6450 West Sunset Boulevard
DOT Case No. CEN20-49786

Subject: **TRANSPORTATION ANALYSIS FOR THE PROPOSED MIXED-USE PROJECT LOCATED AT 6450 WEST SUNSET BOULEVARD (CPC-2020-1929-HD-VCU-MCUP-SPR-RDP-WDI/ENV-2020-1930-EIR)**

The Department of Transportation (DOT) has reviewed the transportation impact study, dated March 2021, prepared by Fehr & Peers for the proposed mixed-use development, located at 6450 West Sunset Boulevard (full project address: 1420-1454 North Wilcox Ave, 6450-6462 West Sunset Avenue, 1413-1447 North Cole Place, and 6503 De Longpre Avenue). In compliance with Senate Bill 743 and the California Environmental Quality Act (CEQA), a vehicle miles traveled (VMT) analysis is required to identify the project's ability to promote the reduction of green-house gas emissions, access to diverse land-uses, and the development of multi-modal networks. The significance of a project's impact in this regard is measured against the VMT thresholds established in DOT's Transportation Assessment Guidelines (TAG), as described below.

Figure 1
Wilcox Avenue Two-Way Left Turn Lane Concept - North
Sunset+Wilcox

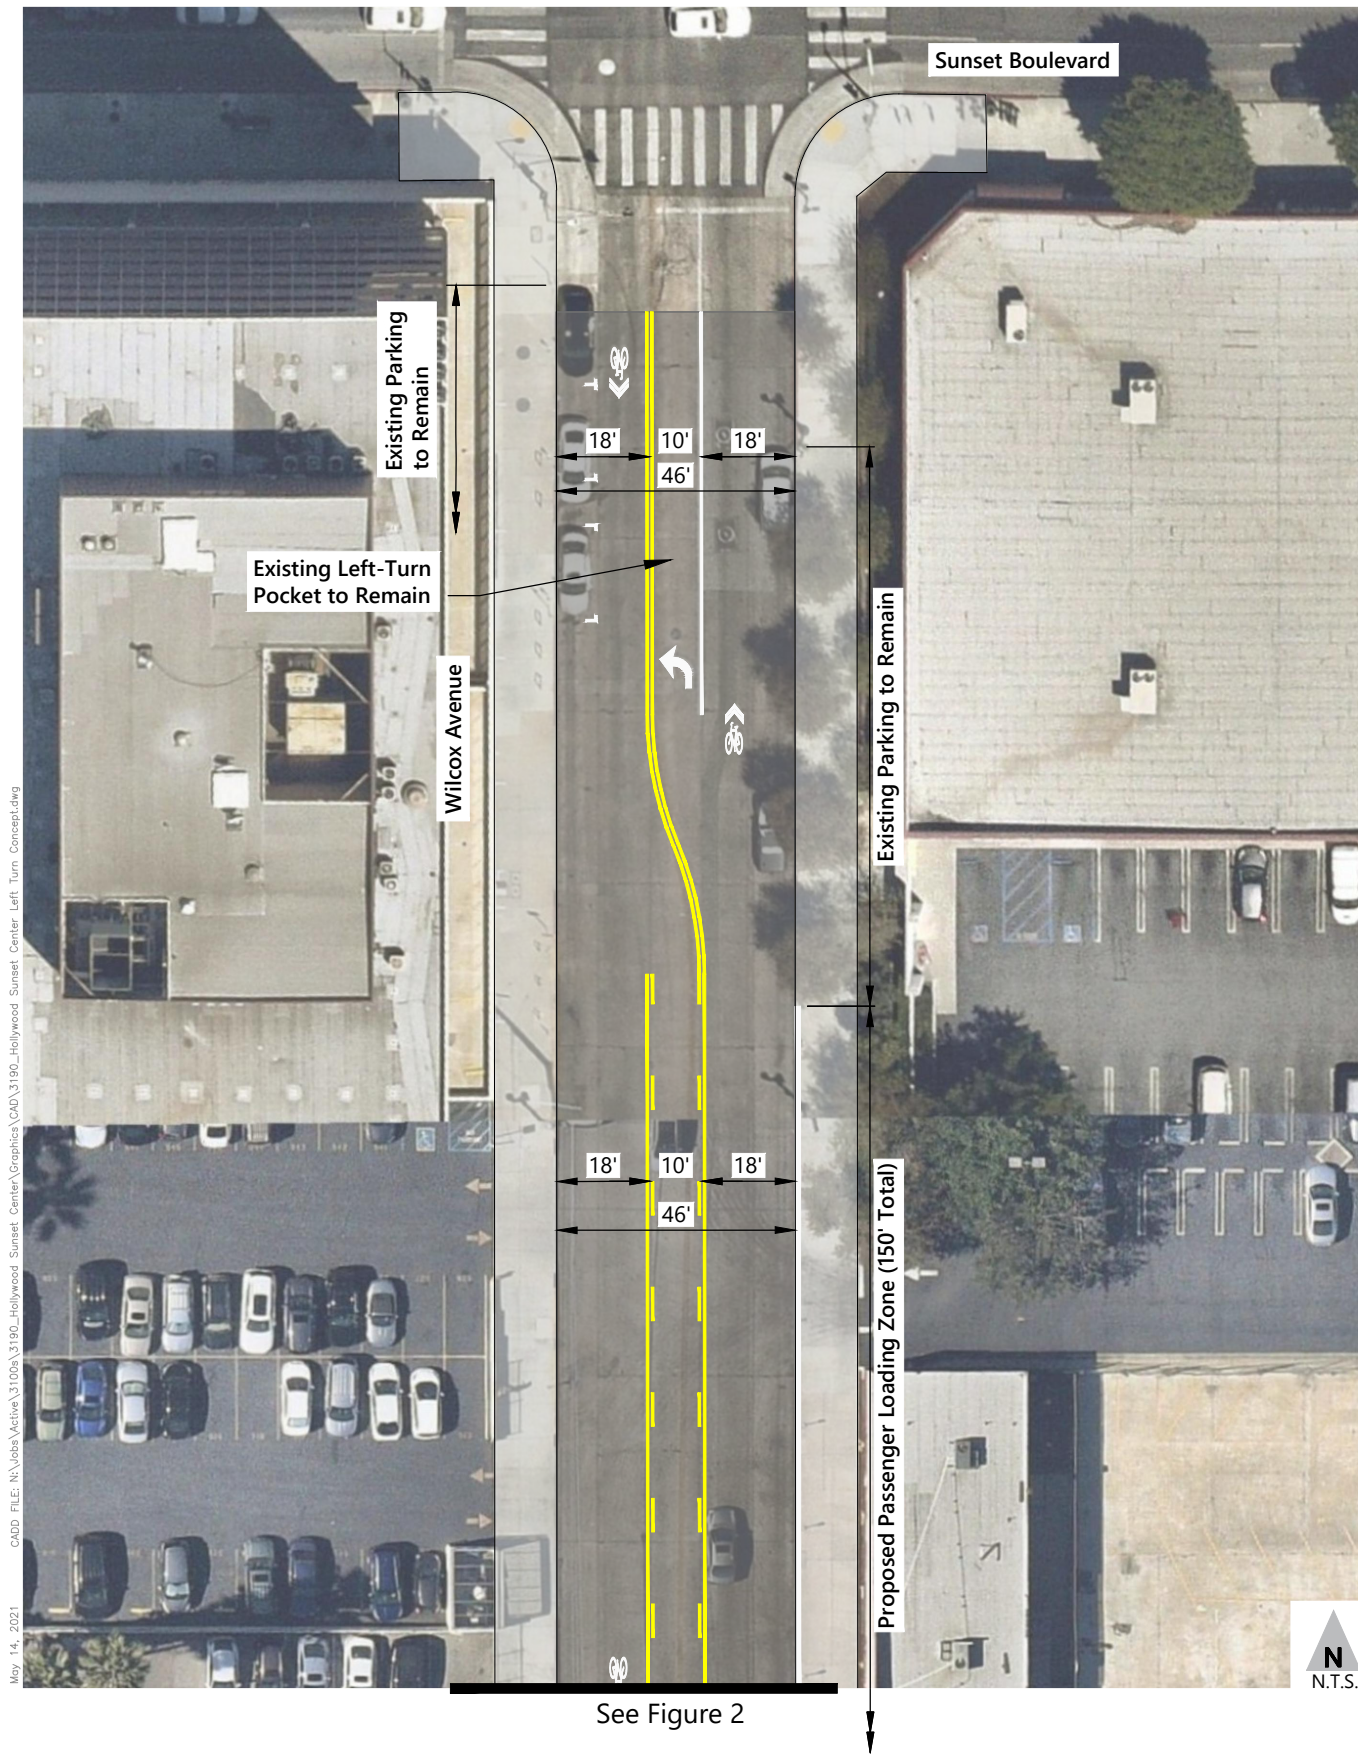
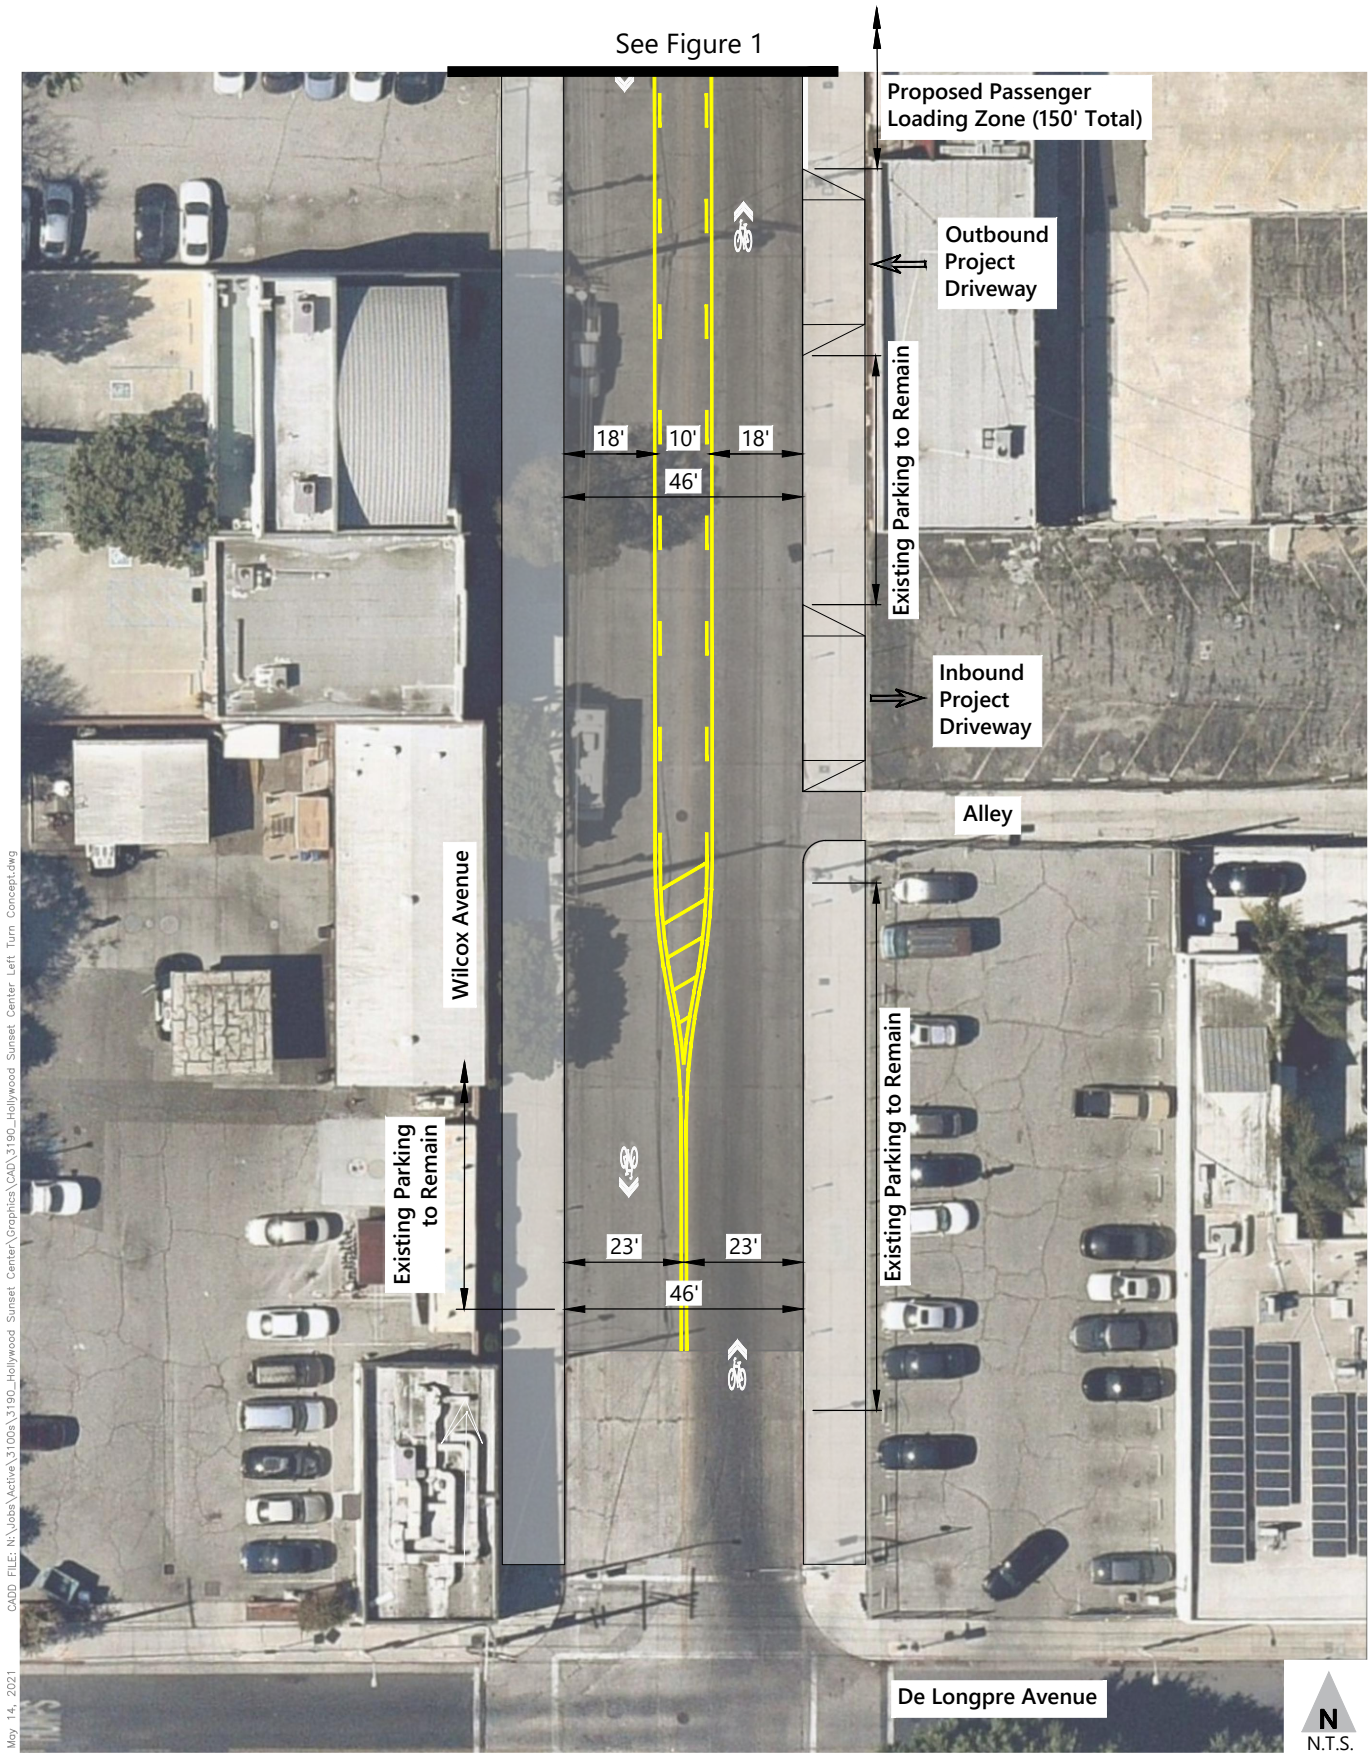
1. Restriping Wilcox Avenue: to provide a center left-turn lane for both directions of travel along Wilcox Avenue. This provides a space for southbound vehicles turning left from Wilcox into the project site to queue without blocking through traffic on Wilcox. Due to existing driveways along Wilcox, a turning lane for both directions is proposed rather than an exclusive pocket turn lane for southbound traffic only. See **Attachment D** for a conceptual design of this proposal.

This proposed corrective measure is subject to review by the LADOT Hollywood-Wilshire District Operations Office, which will also require coordination with the Geometric Design Group.
